City of Portland, Maine - Building or Use Permit Application

Location of Construction: 1127 Westbrook St	Owner Name: Northeast Air	Owner Address: 987 Westbrook St	Phone: 207-774-6318
Business Name: n/a	Contractor Name: Barlo Signs	Contractor Address: 155 Maine Mall Road South Portland	Phone: 2078429002
Lessee/Buyer's Name: n/a	Phone: n/a	Permit Type: Signs - Permanent	Zone: AB

Past Use: Commercial / Fuel Center	Proposed Use: Same: Install 156 SqFt Signage.	Permit Fee:	Cost of Work: \$61.20	CEO District: 3
Proposed Project Description: Install 156 SqFt Signage.		FIRE DEPT: <input type="checkbox"/> Approved <input type="checkbox"/> Denied	INSPECTION: Use Group: Signage	
		Signature: <i>[Signature]</i>		
		PEDESTRIAN ACTIVITIES DISTRICT (P.A.D.)		
		Action: <input type="checkbox"/> Approved <input type="checkbox"/> Approved w/Conditions <input type="checkbox"/> Denied	Signature: _____ Date: _____

Project description: REPLACE REMOVED IRVING AVIATION SIGN WITH NEW EXXON SELF SERVE SIGN AS ATTACHED

→
REINSTALL
SIGN
WHERE
IRVING'S
WAS

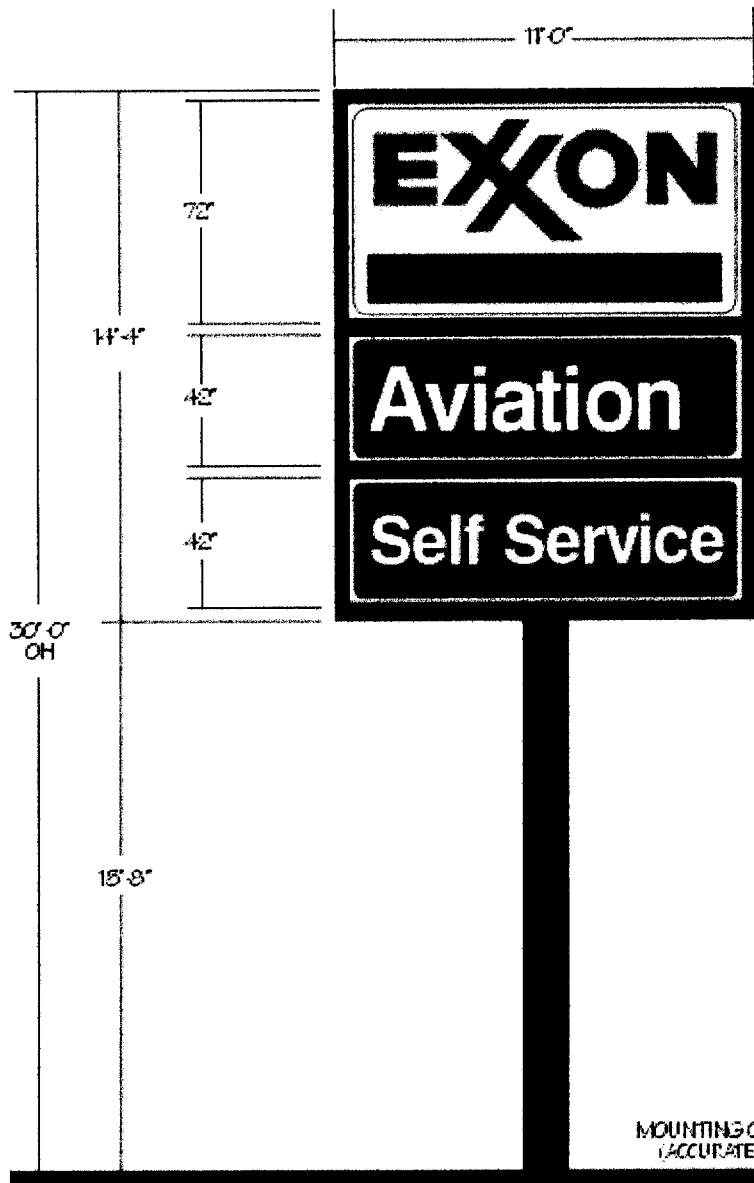
APPROVED PER REVISION UNDER SECS. 14-368.5g + 14-526 OF SITE PLAN ORDINANCE, w/ CONDITION THAT THE SIGN EXTERIOR FACE EAST/WEST, OR THAT THE NORTH-FACING SIDE NOT BE ILLUMINATED.
